**Subdivision Authority**

File No. LDA07-0467

RE: Tentative plan of subdivision to create 59 single detached residential lots, one (1) municipal reserve parcel, one (1) environmental reserve parcel, and one (1) public utilities lot from a portion of SW 36-51-25-4, located east of Rabbit Hill Road and north of Anthony Henday Drive; **MACTAGGART**

## SUBDIVISION CONDITIONS OF APPROVAL MAP

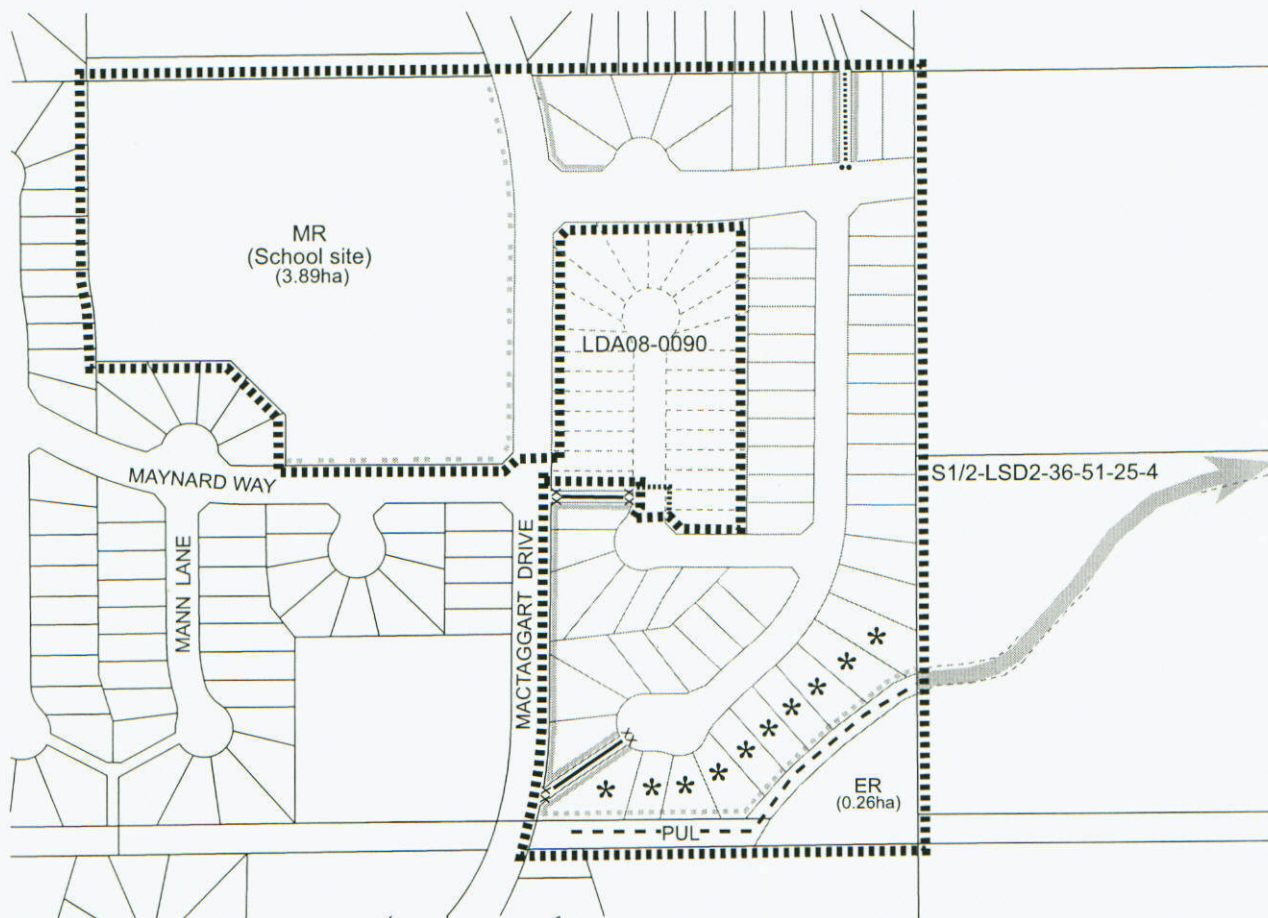
1. that the owner dedicate Environmental Reserve as a 0.26 ha parcel pursuant to Section 664 of the Municipal Government Act as shown on the "Conditions of Approval" map, Enclosure I;

2. that the owner dedicate Municipal Reserve for the land to be subdivided, in the amount of 3.89 ha pursuant to Section 666 of the Municipal Government Act as shown on the "Conditions of Approval" map, Enclosure I;

4. that the owner enter into a Servicing Agreement with the City of Edmonton pursuant to Section 655 of the Municipal Government Act;
5. that the subdivision boundary be amended to include the portion of roadway as shown on the "Conditions of Approval" map, Enclosure I;

7. that the owner prepare restrictive covenants in favour of the City of Edmonton that will be registered against the lots backing onto the top-of-bank as per the applicable development restrictions shown by the Thurber Engineering Ltd. Geotechnical Investigation for Setback Assessment (File No. 19-423-49, November 18, 2008) and the Thurber Engineering Ltd. Setback Assessment Addendum #1 (File No. 19-423-49, November 18, 2008) as shown on the "Conditions of Approval" map, Enclosure I;

8. that the owner provide emergency access/walkway rights-of-way in the locations as shown on the "Conditions of Approval" map, Enclosure I;
9. that the owner register a public access easement on the South ½ LSD2-36-51-25-4 for the multi-use asphalt trail as shown on the "Conditions of Approval" map, Enclosure II; and
10. that the owner pay all outstanding property taxes prior to the endorsement of the plan of subdivision.

7. that the owner provide full servicing, including 3-phase power along the entire frontage of the park/school site;
8. that the owner construct a 3m asphalt multi-use trail with a dividing yellow centreline and "shared use" signage within the top-of-bank setback area and within the ATCO Gas Pipeline Right-of-Way as shown on the "Conditions of Approval" map, Enclosure I;

9. that the owner construct a 3m concrete sidewalk with T bollards and lighting within the emergency access walkways shown on the "Conditions of Approval" map, Enclosure I;

11. that the owner construct all fences positioned wholly on privately-owned lands as shown on the "Conditions of Approval" map, Enclosure I; and
12. that the owner is responsible for the design, landscaping and construction within the public utility lots, utility rights-of-way, road islands, boulevards, medians, walkways, and Municipal Reserve parcels, to the satisfaction of the Community Services, Transportation and Asset Management and Public Works Departments.

SUBDIVISION CONDITIONS OF APPROVAL MAP

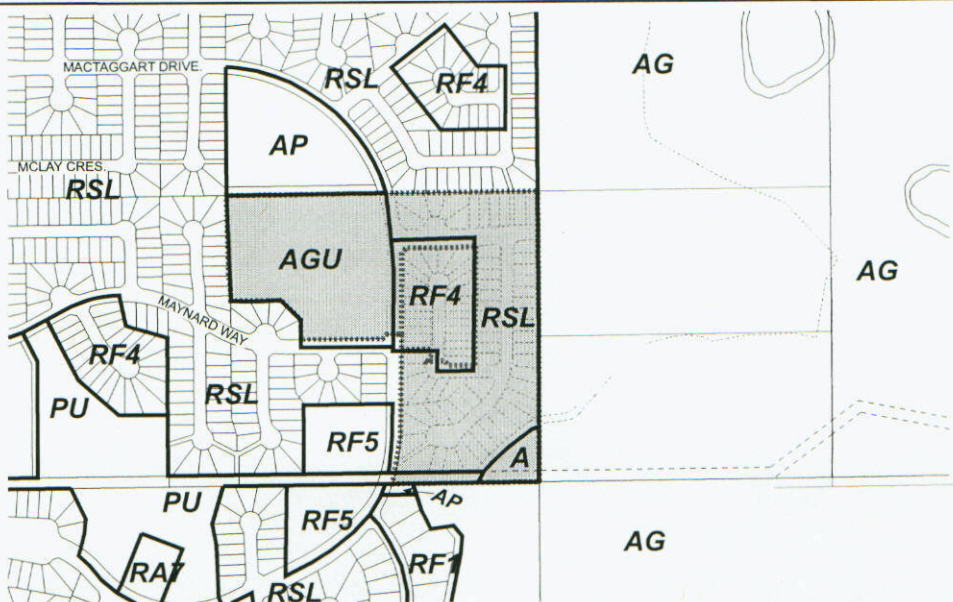
10. that the engineering drawings include a 3m asphalt multi-use trail within the top-of-bank setback area and 1.2m uniform fence along the ravine (south) side of the trail within S1/2 36-51-25-4 as shown on the "Conditions of Approval" map, Enclosure II;
